Service Bulletin

Zierer Bulletin #	Revision:	Page	System	Description:	Date:	Issued:
SB-WS-1001_rev1	1	1 of 4	Wave Swinger	Service Bulletin	17.01.2013	wmt
Original Ride Manufacturer			Release Date	Affected Production Dates:	Ride Name:	
ZIERER – Karussell und Spezialmaschinenbau			18.12.2012	2011 and earlier	Wave Swinger

2. Reason for release:

3.1. Monitoring Devices at Lifting Cables

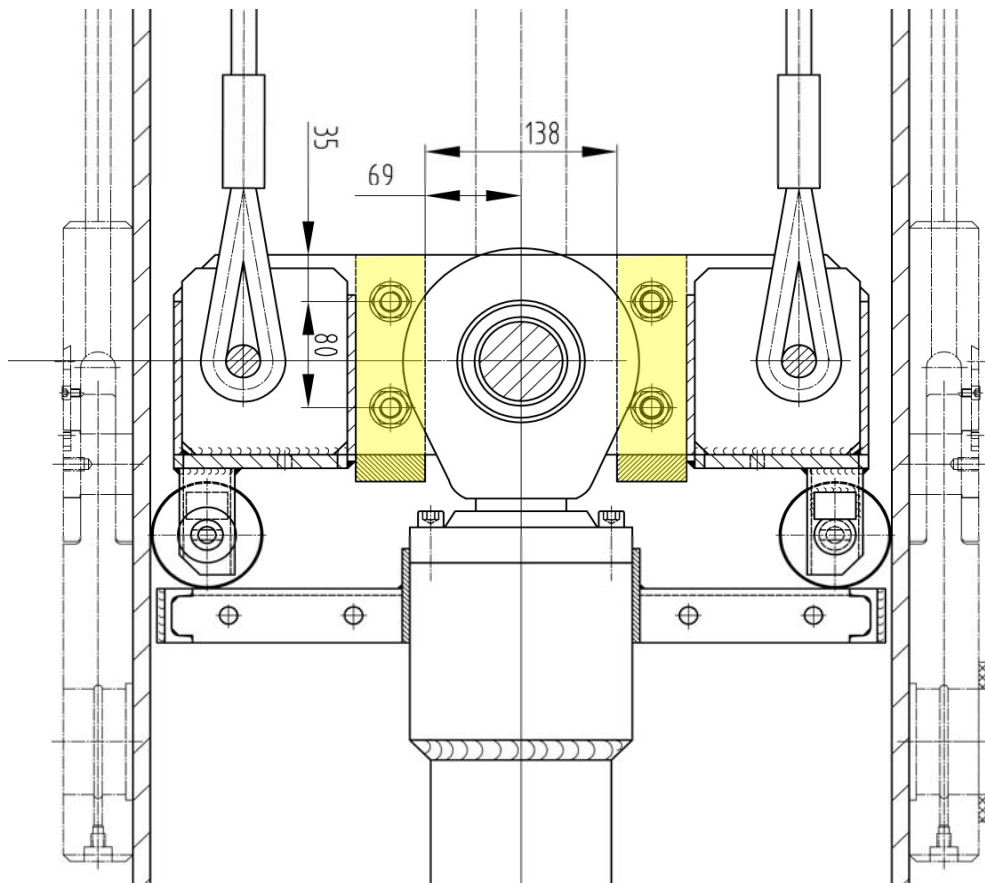
Rope Monitor Zierer Article No.: VK080063

2 sets of sensors monitoring the smooth movement of the lifting cables. The sensors are mounted on a bracket which is bolted to the bottom of the sheave compartment right next to the entry hole of the lifting cables. Their signals need to be integrated into the ride control system subsequently.

If for any reason a cable moves out of sensing range the control system will initiate a “Fast Stop” function .

This modification requires at least three additional slip rings at the slip ring assembly in the lower mast portion. If spare slip rings are available on your unit we recommend the addition of the rope monitor to your Wave Swinger on the next occasion (e.g. winter rehab).

It is no need to take any action if the slip ring assembly on your unit does not have this requirement. Just make sure a thorough daily visual inspection on both sets of lifting cables prior to public operation as well as the required monthly checks over the entire cable length gets carried out.

In case the slip ring assembly on your unit is worn and needs to be replaced soon we would recommend purchasing a slip ring assembly with more slip rings, so that the rope monitor can be added.

3.2 Lifting Cylinder Retaining Elements [Cylinder Rod] Zierer Article No.: HZ020078

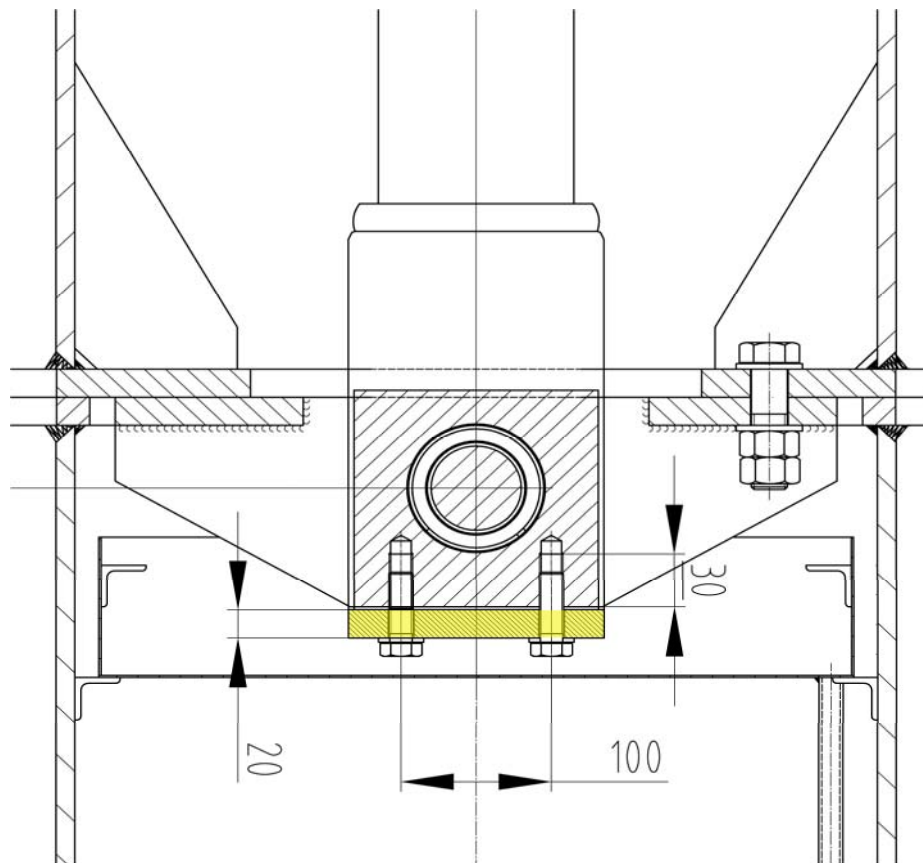
In case of a break of the suspension pin 2 pieces of fork shaped retaining elements preventing the rod end from slipping through the guiding cross. The retaining elements are mounted axially at a distance of 138 mm with 4 bolts to each side of the guiding cross.

We recommend proceeding with this modification on the next occasion (e.g. next winter rehab), provided that the suspension pin has been inspected and documented as requested in the NDT requirement

3.3 Lifting Cylinder Retaining Element [Cylinder Barrel] Zierer Article No.: HZ020079

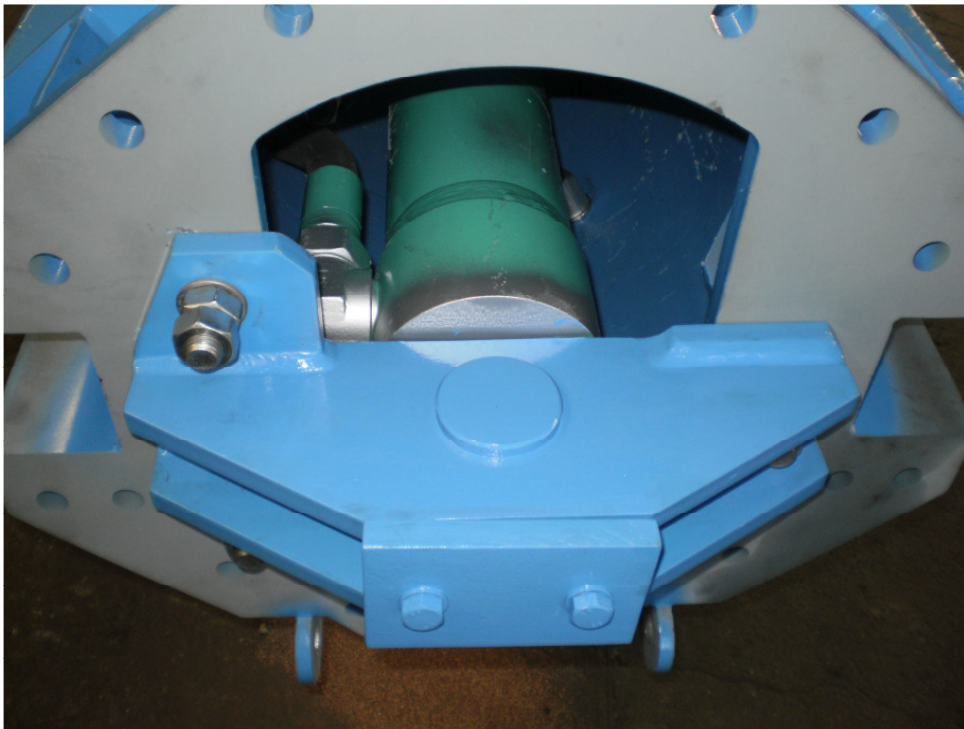
In case of a break of the suspension pin a striker plate prevents the cylinder from slipping out of the clamping device. The striker plate is bolted concentric to the cylinder eye by means of 2 bolts.

This modification requires a rectangular shape of the eye on the cylinder barrel. This can be found only on cylinders built in 2010 or later.

If you have purchased a new cylinder during or after 2010 we recommend proceeding with this modification on the next occasion (e.g. next winter rehab) provided that the suspension pin has been inspected and documented as requested in the NDT requirement.

If the lifting cylinder on your unit does not have this requirement please proceed as usual. By purchasing of a new lifting cylinder the striker plate will be included in the shipment.
